Delegated Report

Householder Planning Application

Planning Application No: 20221079

Description: Erection of ground floor rear balcony and lower ground floor car parking above garden store and terrace

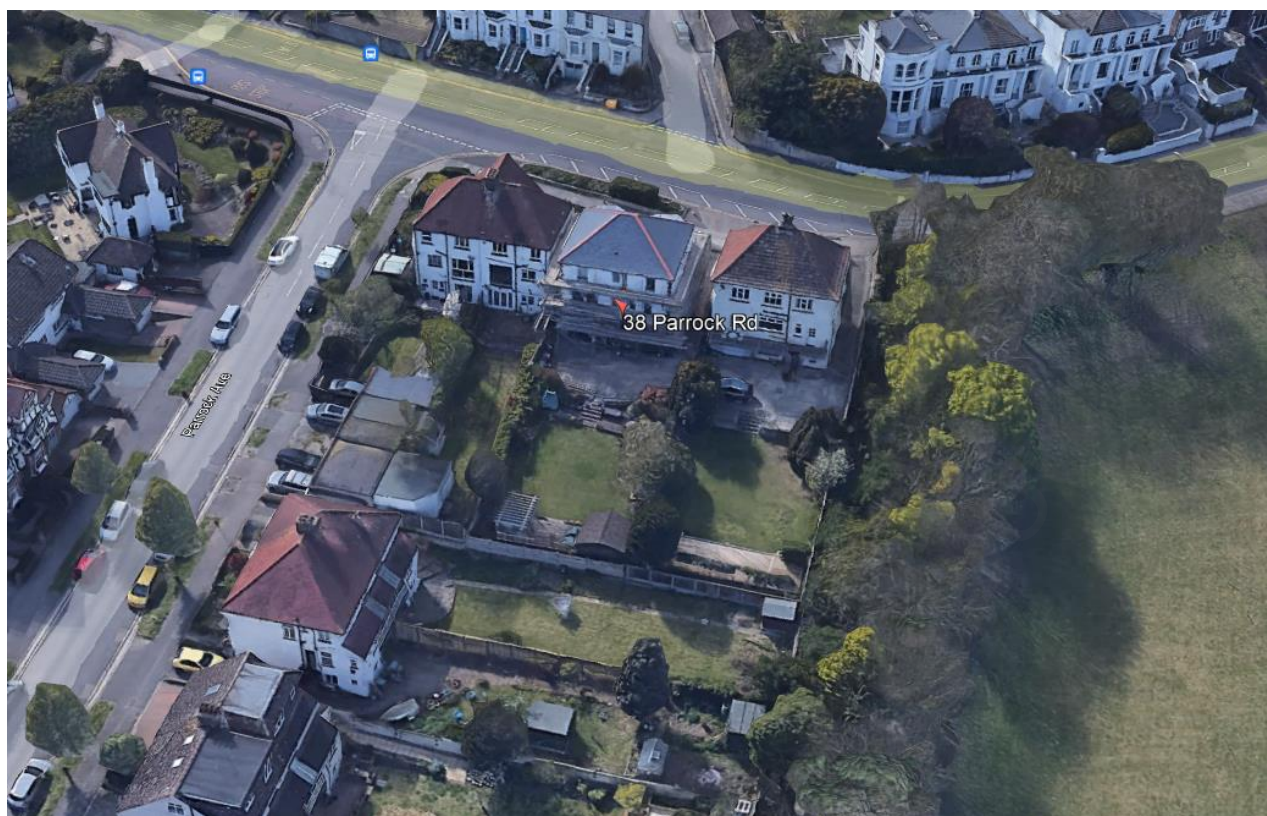
The application site consists of a large detached property situated in a row with three other houses which face onto Parrock Road and with a rear garden some 25m in depth, the rear boundary of which borders onto no. 4 Parrock Avenue. Due to the slope of the land, the front elevation of no. 38 presents itself as two storeys to Parrock Street and three storeys to the rear elevation.

The proposal includes the erection of a balcony on the rear elevation of the property. Due to the slope of the land although the balcony would be at ground level in terms of the internal order of the dwelling, it would actually be at first floor level on the rear elevation of the dwelling with its actual platform being located just under the first floor level doors at that level. It would be 9.7m in width extending the majority of the rear elevation of the dwelling and would be 1.7m in depth. It would be supported on steel posts and have obscured toughened and laminated frameless clear glass 2000mm high above finished floor level on both sides of the balcony and 1100mm high on the front of the balcony.

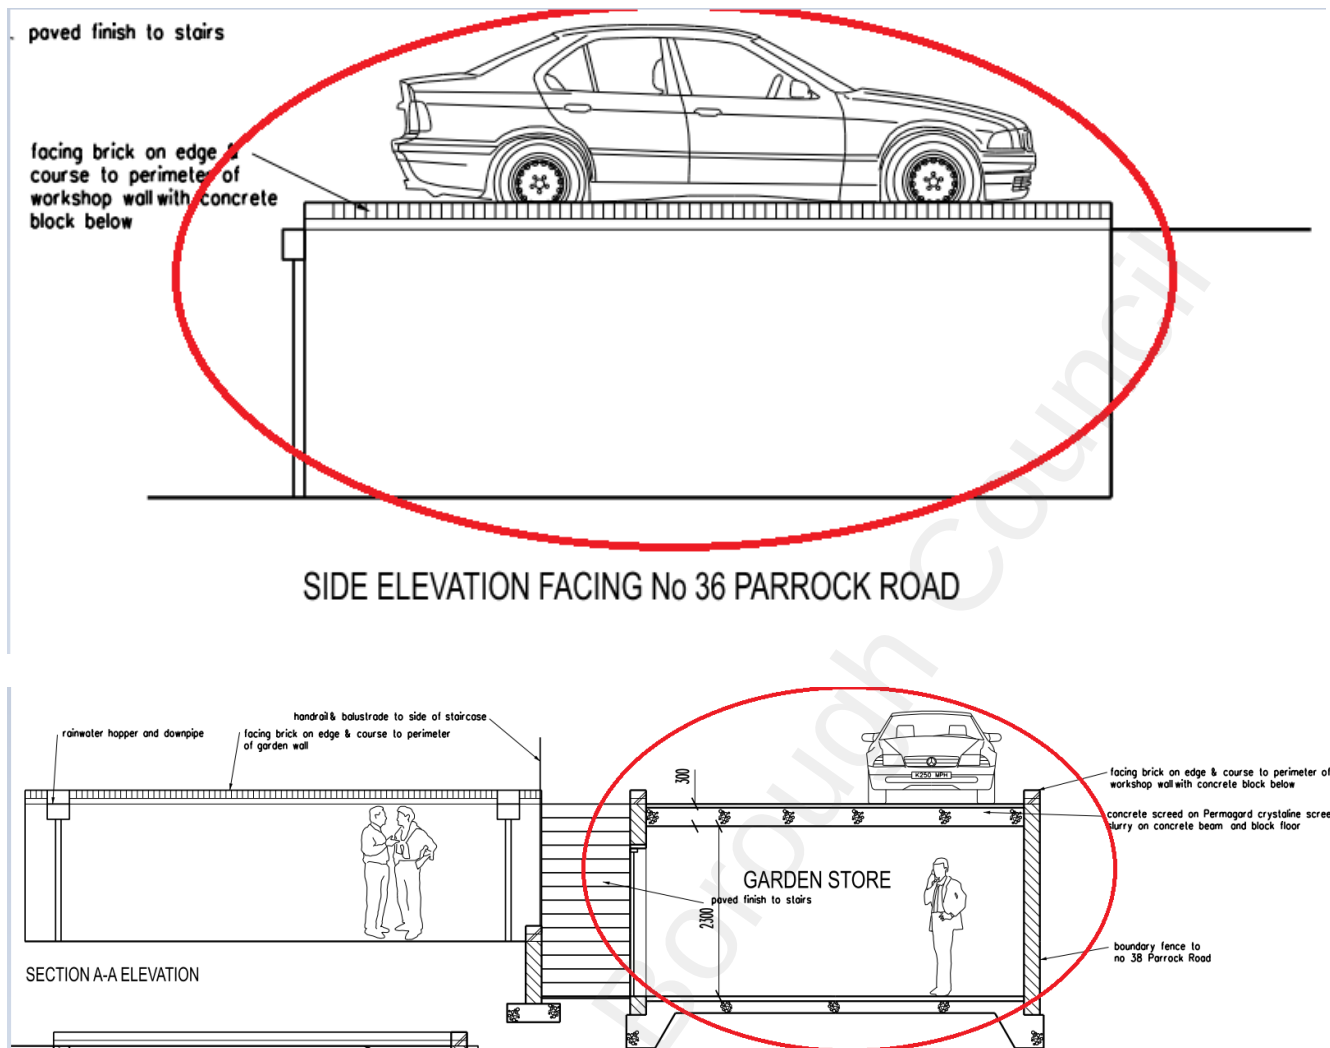
The proposed balcony would be located at first floor level on the rear elevation of the dwelling with the platform underneath the two doors at that level:

Due to the level the balcony at the application site would be in comparison to the height of the balcony at no. 36 .i.e. higher than it, the proposed balcony would cause direct overlooking down into the balcony at no. 36. Although 2m high obscure glass panels are proposed on either side of the balcony it would still be the case that individuals on the proposed balcony would have views down into the private garden areas of the neighbouring properties either side by an individual just looking out from the front of the balcony (which would have 1.1m high clear glazing). This is particularly the case with no. 36 which has its private rear garden area start further down due to the hardstanding parking area immediately to the rear of the dwelling (as it is used for parking that hardstanding area does not constitute private garden area). Occupiers of the dwelling would therefore be overlooked when using their garden which would be harmful to their amenity. Views would also be possible into the rear garden of the neighbouring property to the south no.40 Parrock Road which although would not be the first 5m of private garden area would still give views over the majority of the garden which would result in occupiers of that dwelling being overlooked when using their garden harmful to their amenity. As stated, it is noted that the neighbouring property has a balcony but as there is no record of planning permission for this it is considered to hold limited weight and not justify allowing the proposed balcony in this case.
